**Re: Regional District of Okanagan Similkameen Electoral Area A Official  
Community Plan and Zoning Amendment Bylaw Nos. 2450.14 and 2451.27**

The Bylaws propose to amend the OCP land use designation from Large Holdings (LH) to Small Holdings (SH) and Conservation Area (CA) and the amend the zoning from Large Holding One Zone (LH1) to Small Holdings Three Zone (SH3) and Conservation Area (CA) on the property identified as 1750 Highway 3E; PID: 002-165-481 (the "Property") in order to facilitate a bareland strata subdivision of five residential lots and one conservation lot.

**Re: Comments regarding file A2018.207-ZONE**

***Proposal Map:***

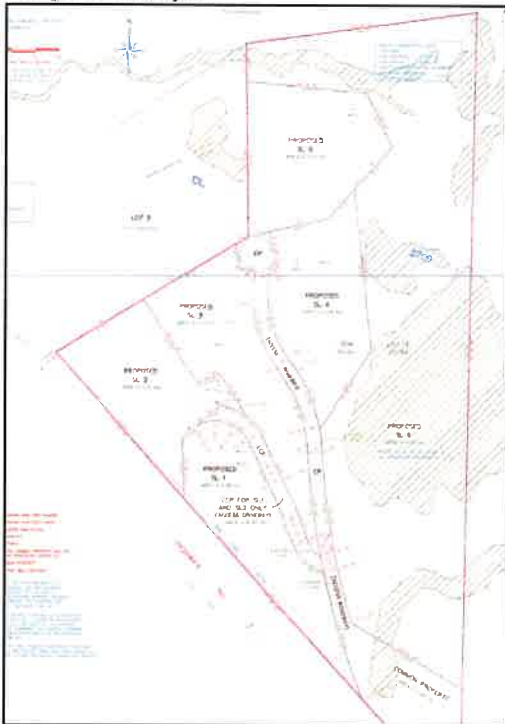
The ALC recognizes that the Property is not within the ALR and while separated by Highway 3, is adjacent to ALR lands. In particular, Strata Lot 1 and 2 are adjacent to the Highway. For this reason, ALC staff recommends considering the setback and buffer requirements outlined in the [Guide to Edge Planning](#), including up to a 30 m building setback from the ALR boundary, and an associated 7.5 m vegetated buffer to reduce the potential for urban/agricultural conflicts.
